ULNRC- 05224

**DOCKET NUMBER 50-483
CALLAWAY PLANT
UNION ELECTRIC COMPANY
SUPPLEMENT/REVISION TO LICENSE AMENDMENT REQUEST OL-1258
FOR REVISION OF TECHNICAL SPECIFICATION 3.7.3,
"MAIN FEEDWATER ISOLATION VALVES (MFIVs)"**

MARKED-UP OF TECHNICAL SPECIFICATION PAGES

Figure 3.7.3-1 (Page 1 of 1)
MFIV Stroke Time Limit vs Steam Generator Pressure
3.7-8a

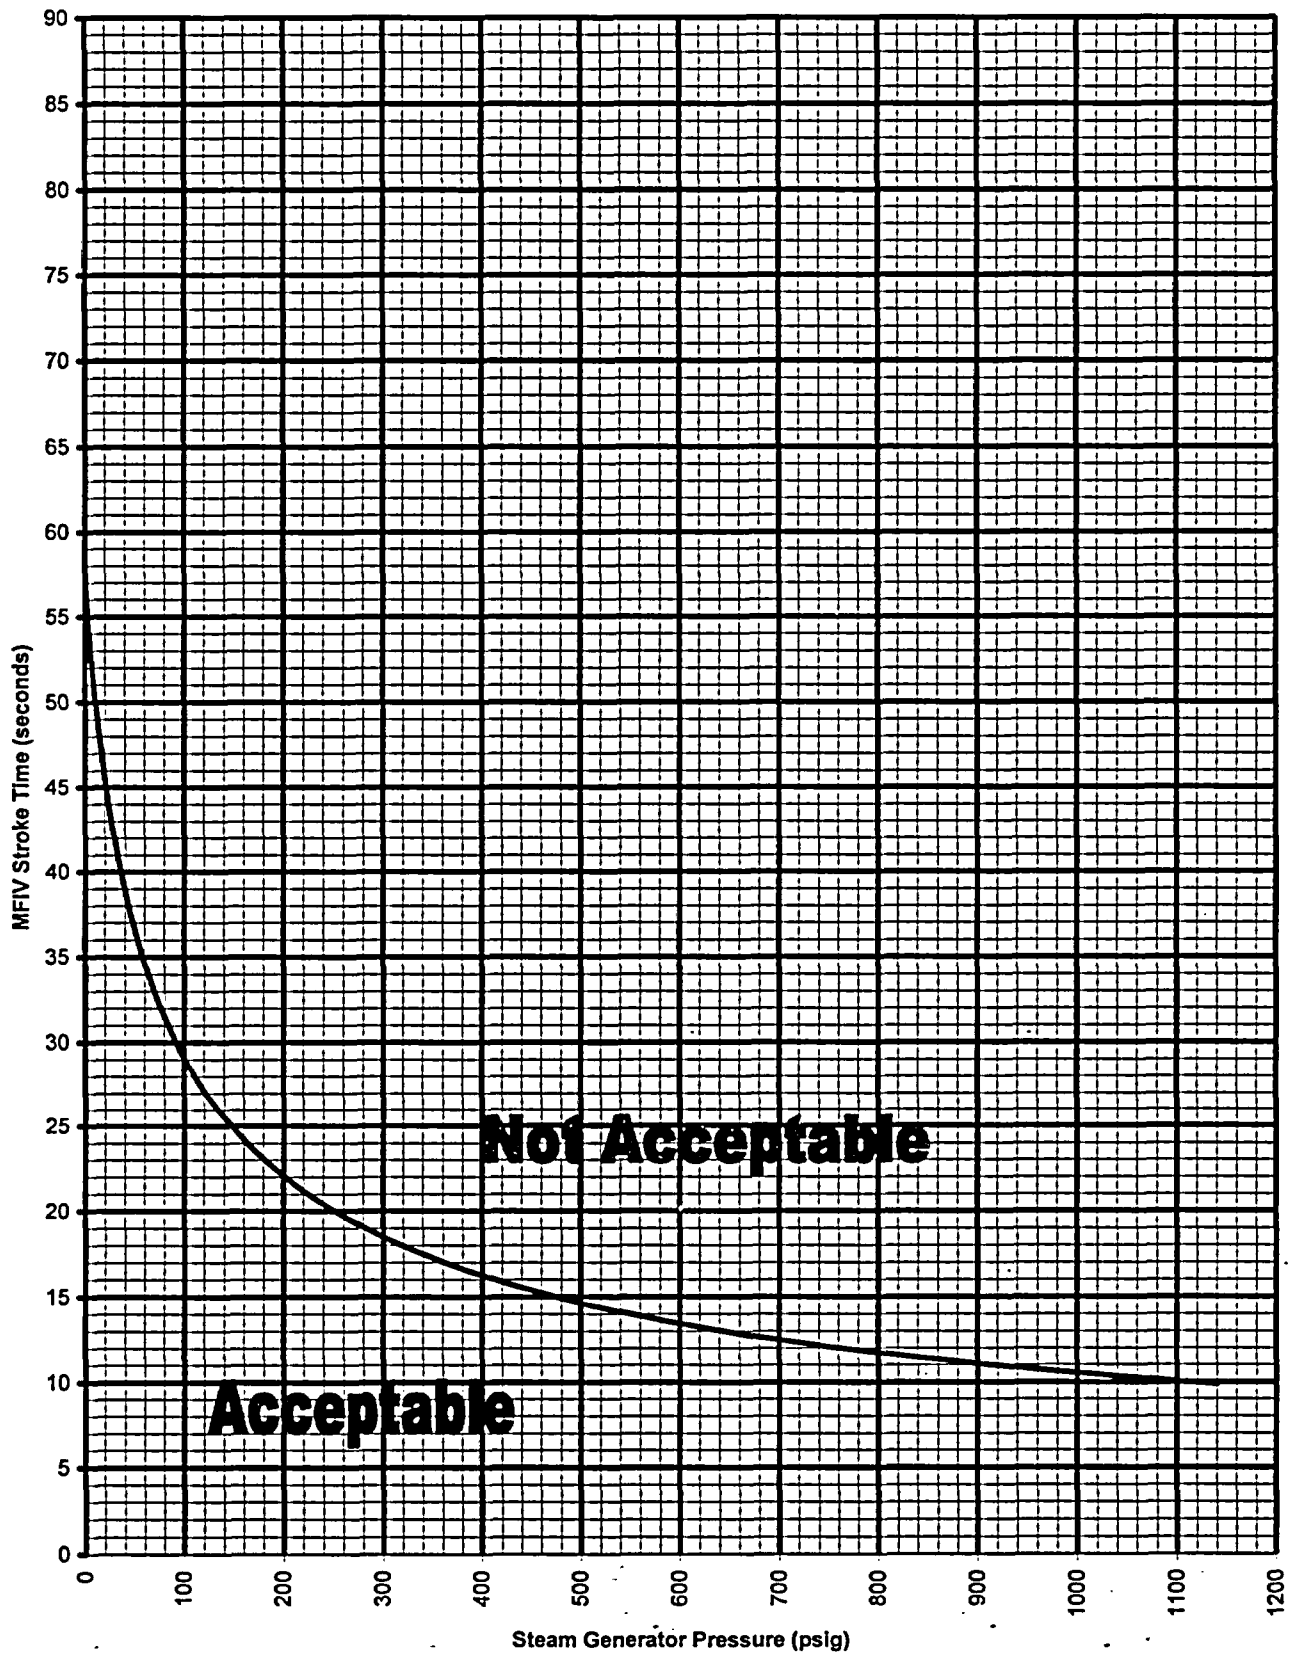
SR 3.7.3.3 Verify the closure time of each MFIV is within the limits of Figure 3.7.3-1.	In accordance with the Inservice Testing Program
---	---

1. *The safety analysis limit curve for the MFIV closure time is presented in the figure provided in Attachment 6 to ULNRC-05206. This curve shows the MFIV safety analysis limits are 90 seconds at or below the P-11 permissive, and 15 seconds above the P-11 permissive. Therefore, it appears that this license amendment request is to change the safety analysis limit for the MFIV closure time from 15 seconds to 90 seconds at or below the P-11 permissive, but that the safety analysis limit above P-11 (i.e., the 15 seconds) is not being changed. The proposed Figure 3.7.3-1 (showing the acceptable MFIV closure times as a function of SG pressure) has a curve which is always less than the two MFIV safety analysis limits, so that demonstrating the MFIV closure time is within the acceptable range in Figure 3.7.3-1 would demonstrate that the measured MFIV closure time is also within the safety analysis limits and, therefore, the MFIV is operable with respect to its closure time. Discuss if the NRC staff's interpretation of the amendment request is correct and why, if the MFIV safety analysis limit above the P-11 permissive is not being changed, the effect of the 15-second closure time on accidents above the P-11 permissive is addressed in ULNRC-05206.*

7. *In the background on the MFIV actuators, on pages 2 and 3 of Attachment 1 to ULNRC-05206, there are the statements that the actuators use the pressure of the process fluid to close the MFIVs, an inherent feature of the actuators is that the valve closure time is a function of the system conditions (pressure and temperature), and the valves tend to close more slowly at lower SG pressure. Explain the relationship used to correlate the system conditions at the MFIVs to the pressure in the SGs so that the MFIV closure time in Figure 3.7.3-1 is presented as a function of the SG pressure.*

8. *Given the figure in Attachment 6 to ULNRC-05206 on the measured MFIV closure time as a function of SG pressure, explain the basis for the assumption of a 90-second maximum time for MFIV closure at or below the P-11 permissive. (Below the P-11 permissive SG pressure, the maximum MFIV stroke time is shown in proposed Figure 3.7.3-1, for zero SG pressure, to be less than 60 seconds.)*

11. *In the discussion on the implementation of MFIV testing required by SR 3.7.3.3 on page 11 of Attachment 1 to ULNRC-05206, it is stated that "it is AmerenUE's intent to perform stroke-time 'baseline' testing of the MFIVs at several pressure values over the test pressure range." Address this statement by describing what testing has been done on the MFIVs prior to this application and what testing will be done during the implementation of this proposed amendment including the test pressure range. Address the testing that would be done for "actual plant conditions (using only a single actuation train to stroke each MFIV)" and how the curve for the "calculated single train stroke time" in the MFIV closure time versus SG pressure figure, which is in Attachment 6 to ULNRC-05206, was determined. For the testing during implementation of the proposed amendment, discuss the assurance that Figure 3.7.3-1 will bound any testing of the MFIVs and what would be done if the testing using a single actuator train would show that Figure 3.7.3-1 is not conservative.*

13. *In the footnote on the bottom of page 3 of Attachment 1 to ULNRC-05206, there is the statement that the TS surveillance does not explicitly state that closure time testing of the MFIVs is done using one actuator train. However, in Attachment 4 to ULNRC-05206, there is the following statement in Insert 4 for page B 3.7.3-7 of the TS 3.7.3 Bases for SR 3.7.3.3: "This SR verifies that the closure time of each MFIV is within the limits of Figure 3.7.3-1 from each actuation train when tested pursuant to the Inservice Testing Program." Discuss if this sentence would require that the verification specified in SR 3.7.3.3 would be for each MFIV with only one actuator train working. Include in this discussion, the answers to the following questions:*

Is the measured closure time for each MFIV with only one actuator train working compared to the closure time in proposed Figure 3.7.3-1, or is the MFIV tested with both actuators working and then corrected for the single failure of one actuator train? Is the proposed Figure 3.7.3-1 for only one actuator train, or for both trains, working to close an MFIV.

The above interpretation is correct with respect to what is shown on proposed Figure 3.7.3-1, but it should be noted that it is not the intent of the license amendment request (LAR) to request changing the safety analysis limit for the MFIV closure time from 15 to 90 seconds. More precisely, the LAR was submitted for the purpose of changing the Technical Specification acceptance criteria for the MFIV closure time.

The vendor-calculated single-train performance curve was established using shop test data and validated with Callaway-specific single-actuation train field test data under high Mode 4 and Mode 3 normal operating pressure/normal operating temperature (NOP/NOT) conditions. To establish desired stroke time test margin, discussions with Westinghouse determined that a stroke time of 90 seconds below P-11 could be supported through re-evaluation and re-analyses. Based upon this information, the vendor-supplied single-train performance curve was adjusted upwards to provide test acceptance criteria that would be well within the analysis values, particularly the limit of 90 seconds with no steam generator steam pressure at the MFIV. This pressure-based performance curve was then correlated to steam generator steam pressure by conservatively reducing the pressure for each corresponding stroke time point on the curve by 19.1 psig [which is the difference in head elevation between RSG water level at 100% (narrow range) and the elevation of the MFIVs], thus establishing the curve provided as proposed Figure 3.7.3-1.

Consistent with the response to Question 7, an analysis stroke time limit of 90 seconds was selected for the range of pressure below the value corresponding to P-11 in order to fully bound expected stroke times in this range relative to the applicable accident analyses as re-evaluated for the RSGs. This provides margin between the limits/assumptions of the safety analyses and the test acceptance criteria developed for the MFIVs at low pressures.

The footnote and Bases insert are consistent in their description of how the MFIVs are to be tested. That is, each MFIV will be closed (when stroke-time tested pursuant to proposed SR 3.7.3.3) via only one of its two actuation trains at a time. Proposed TS Figure 3.7.3-1, which is the same plot indicated by the "Sample TS Curve" on the figure provided as Attachment 6 to ULNRC-05206, assumes and is based on each MFIV being closed via a single actuation train. Attachment 6 includes additional plots such as the Calculated Dual Train Stroke Time and the Calculated Single Train Stroke Time to provide an indication of how different the test results could be when stroking the valves closed using both actuation trains versus a single train. Nevertheless, testing pursuant to SR 3.7.3.3 will require each MFIV to be closed via only a single actuation train, consistent with single-failure/redundancy concepts incorporated into the MFIV design (i.e., that either actuation train can effect closure of the MFIV(s) in the event of a failure or unavailability of the other train). As noted in the LAR, the curve of proposed Figure 3.7.3-1, which constitutes the acceptance criteria for this SR, will be validated by testing (using only a single actuation train at a time for each MFIV) as part of the implementation of the requested license amendment.
